SUBJECT: ISSUANCE OF AMENDMENT NOS. 59 AND 39 TO FACILITY OPERATING LICENSES  
NPF-11 AND NO. NPF-18 - LASALLE COUNTY STATION, UNITS 1 AND 2  
(TAC NOS. 66061 AND 66062)

The amendments revise the LaSalle County Station, Units 1 and 2 Technical Specifications to correct an inconsistency between requirements regarding the suppression pool high level alarm.

Amendment No. 59  
License No. NPF-11

Amendment No. 39  
License No. NPF-18

BASES FIGURE B 3/4.6.2-1

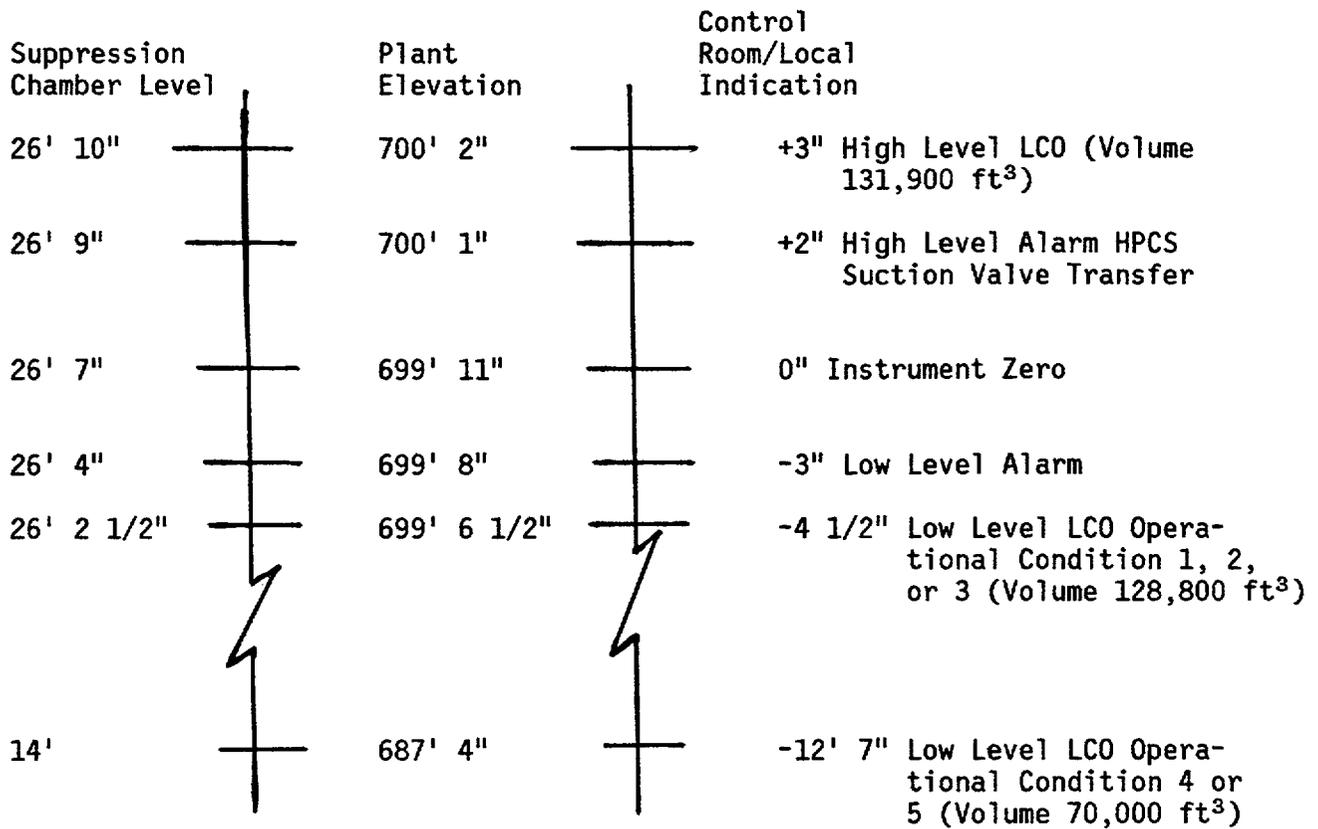
\*Level is referenced to a plant elevation of 699 feet 11 inches (See Figure B 3/4.6.2-1).

The suppression chamber water provides the heat sink for the reactor coolant system energy release following a postulated rupture of the system. The suppression chamber water volume must absorb the associated decay and structural sensible heat released during reactor coolant system blowdown from 1020 psig. Since all of the gases in the drywell are purged into the suppression chamber air space during a loss of coolant accident, the pressure of the liquid must not exceed 45 psig, the suppression chamber maximum pressure. The design volume of the suppression chamber, water and air, was obtained by considering that the total volume of reactor coolant and to be considered is discharged to the suppression chamber and that the drywell volume is purged to the suppression chamber. (See Figure B 3/4.6.2-1)

1. The suppression pool high water level alarm setpoint in Technical Specification 4.6.2.1.c.1 be raised 1 inch to be consistent with Technical Specification Table 3.3.3-2 and the UFSAR.
2. All references to suppression pool level in the Technical Specifications be amended to be consistent with plant indications.
3. A figure be added to the Technical Specification bases which will correlate plant evaluation, suppression chamber levels and suppression pool level indications.

1. The suppression pool high water level alarm setpoint in Technical Specification 4.6.2.1.c.1 has been raised 1 inch to be consistent with Technical Specification Table 3.3.3-2 and the UFSAR.
2. All references to suppression pool level in the Technical Specifications have been amended to be consistent with plant indications.
3. A figure has been added to the Technical Specification bases which correlates plant elevation, suppression chamber levels and suppression pool level indications.
